Interactive comment on “Can global precipitation datasets benefit the estimation of the area to be cropped in irrigated agriculture?” by Alexander Kaune et al.

Received and published: 27 February 2019

Fig. 1.

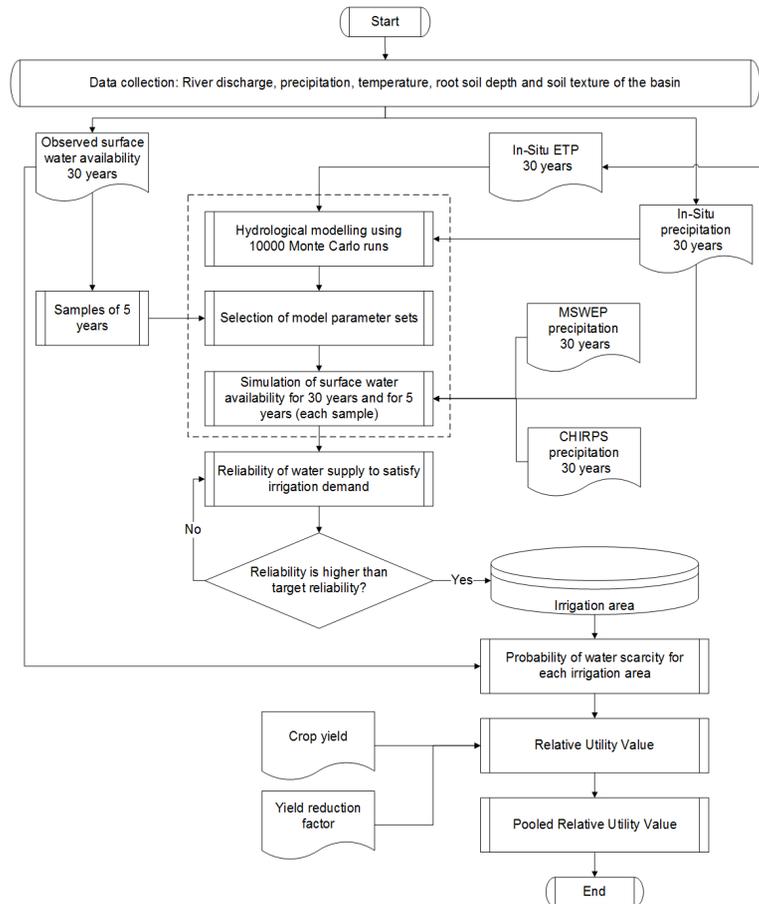
1) My greatest concerns are related to the form of the document that I found difficult to follow. The different tools used in the study are described independently in the second part of the manuscript (Method). The result is that the reader discovers the approach and the different steps of the work gradually. The whole approach is (well) summarized in the first part of the discussion section. It could be moved earlier in the text, maybe at the beginning of section 2 and I propose also to add a scheme describing the workflow of the study.

Reply: We moved the approach of our research that is now described in the discussion section to section 2 (beginning of the method section). Additionally, we added a schematic diagram to clarify workflow of the study (Figure 1). Figure 1. Workflow of

the study to determine the Pooled Relative Utility Value using different irrigation areas obtained from In-Situ, CHIRPS and MSWEP precipitation datasets.

Fig. 2.

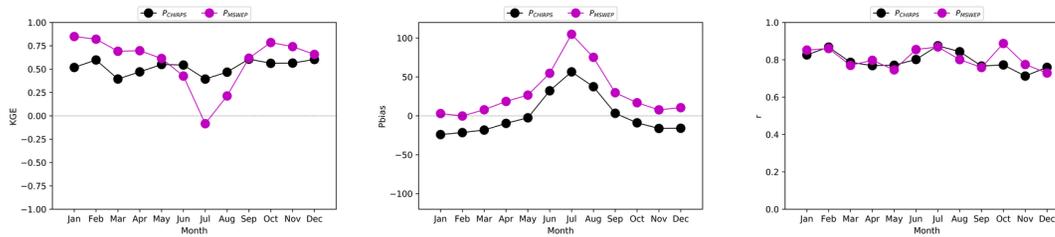
3) Finally, as global precipitation products are at the center of the study and in situ data are available, an evaluation of the global data sets should be conducted as a preliminary step. This could give some quantitative elements for the discussion. Indeed, from the three precipitation data sets compared in this paper (CHIRPS, MSWEP and in situ network data), CHIRPS appear the best suited to plan irrigated areas but we don't really know the reasons. Is it because it is able to better catch the real spatio-temporal variability of the catchment precipitation than the in situ data set because of station scarcity? Maybe if the worst data set (MSWEP) appears to be strongly biased or strongly inaccurate and that the model calibration is not able to compensate for this data set deficiencies, it could be discarded the rest of the study (after section 3.1 "discharge simulations"). This could significantly simplify the results and discussion sections (and also the figures). Regarding this last point, I believe that the number of figures could be also reduced (cf. specific comments). Regarding the comments above, I recommend a major revision.

Reply: We added an evaluation of the global precipitation datasets as a preliminary step. We compared global precipitation datasets (CHIRPS and MSWEP) against in situ data in the selected basin. We used performance indicators KGE, percentage of bias (Pbias) and Pearson correlation (r). The evaluation was done for multi-annual monthly precipitation for the selected period 1983-2012 (new Figure 4).

Figure 4. KGE, Pbias and r performance metric for monthly CHIRPS and MSWEP

precipitation in the Coello basin for 30 years (1983-2012).

KGE results show that MSWEP performs better than CHIRPS from October to May. Only in July, MSWEP performs poorly ($KGE=-0.1$, $Pbias=100\%$). We cannot discard the use of MSWEP neither of CHIRPS. At this stage, we can recommend the use of each dataset for specific months. Important to mention is the fact that CHIRPS and MSWEP are gauge corrected. This would mean that they would both be expected to perform quite well. However, the datasets used to correct each product may differ. That is way we compare the amount of stations used in the Coello basin for each of the precipitation products (In-Situ, CHIRPS and MSWEP). This is helpful for discussing the PRUV results. Even though the amount of stations used is lower for correction in the CHIRPS product (7 stations) compared to the number of stations used in the In-Situ product (14), the results indicate that the satellite information included in CHIRPS still provides a reasonable representation of the basin precipitation. For the MSWEP product the only three stations are used for correction, resulting in a poorer representation of the rainfall in the basin. In summary, the basin precipitation dataset derived from CHIRPS for the Coello basin is better than the MSWEP. The higher resolution of the CHIRPS dataset when compared to that of MSWEP no doubt also contributes in this medium sized, mountainous basin. The poorer comparison of the MSWEP data we found not to be immediately obvious when evaluating the precipitation data using common indicators (e.g. KGE, bias), but was only found when evaluating the hydrological information for determining the irrigated area. As our objective is to evaluate the best hydrological information for irrigation area planning, we do think it relevant to include the RUV and PRUV indicators for all precipitation products, including MSWEP.

Fig. 3.

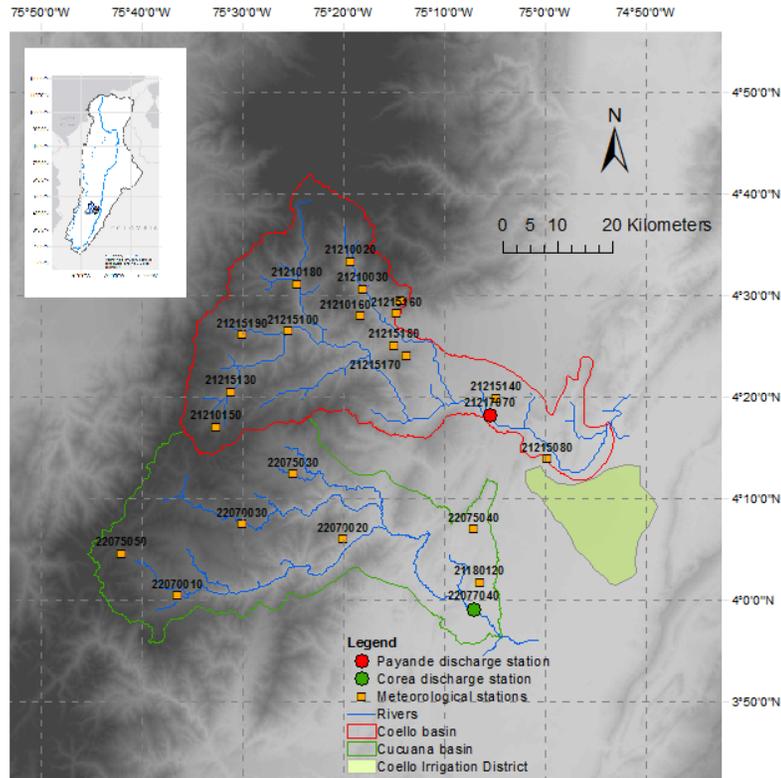
2.2 Could you map the network of the meteorological stations (at least provide the number of stations)? How is measured the discharge? Is the river bed changing overtime?

Reply: We improved the map by including the network of the meteorological stations and providing the number of stations. The map is shown in Figure 2.

Figure 2. Map of the Coello and Cucuana River basins and the Coello irrigation district, and their location in the Magdalena macro-basin in Colombia. The points indicate discharge stations and the squares indicate meteorological stations

Fig. 4.

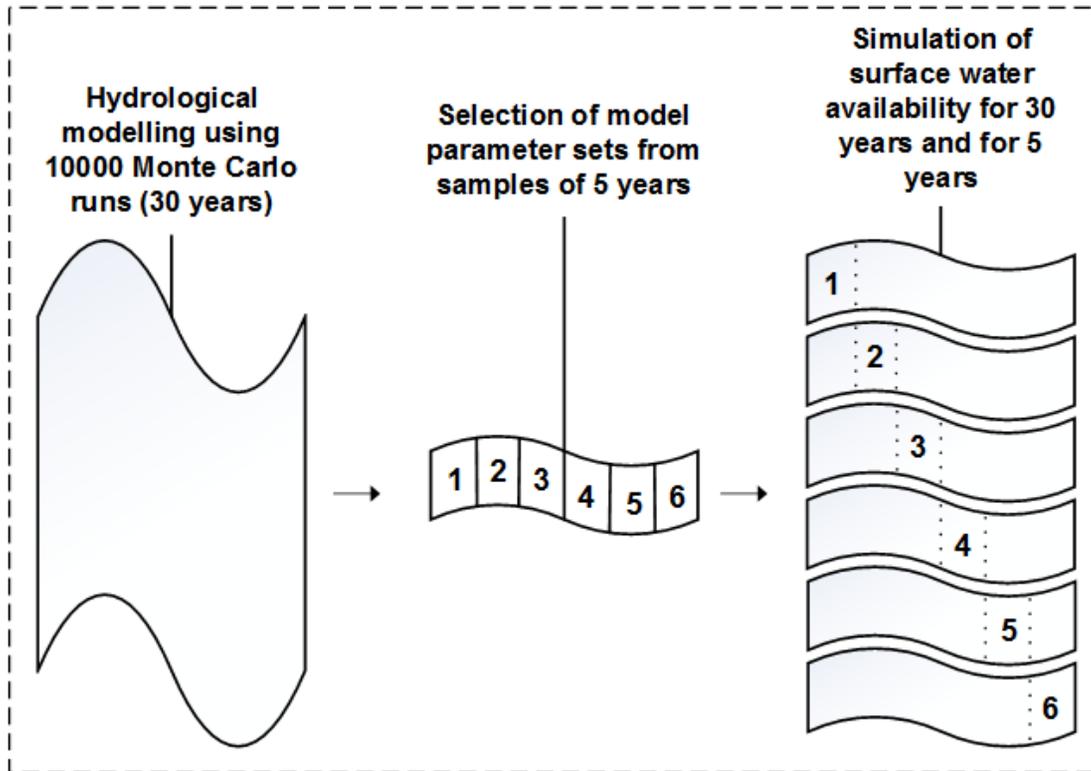
are determined the physical soil and the vegetation characteristics? Could you please explain how you determine a maximum soil moisture storage capacity max S of 176 mm from the physical soil and vegetation characteristics? Calibration of the models (L19-29) should be re-written as it is not clear whether the model are calibrated on the full period or on five-years period. I assume the second option has been adopted. The best 5 models from the Monte-Carlo simulation with 10000 ensemble members are then kept which gives five models by 6 periods, 30 calibrated models. I think that the sentence beginning by “10000 models...” is confusing.

Reply: In section 2.3 we described in more detail how the input data for the hydrological model is generated. We completed the description on how the maximum soil moisture storage capacity () is obtained. An average maximum soil moisture storage capacity of 176 mm was determined for the Coello basin based on the soil texture and the depth of roots in the region. The soil texture and the depth of roots were derived from soil and vegetation maps provided by the Instituto Geográfico Agustín Codazzi in Colombia at a scale of 1:500,000 (IGAC, 2003). Typical values of the available water storage capacity of the soil in millimetres per meters of depth were used based on the soil texture (Shukla, 2013). These values were multiplied by the depth of roots to determine the maximum soil moisture storage capacity in the basin. The calibration of the models (L19-29) will be re-written to make it clear that the model is calibrated for a five year period. Also, Figure 3 was modified to better describe model calibration details. Before the sentence beginning by “10000 models...” we will include the following sentence: “Preliminary a Monte Carlo simulation was developed to obtain the full period of samples and then extracting each sample for calibration”.

Figure 3. Obtaining hydrological model simulations from the six samples of 5 years of observed river discharge.
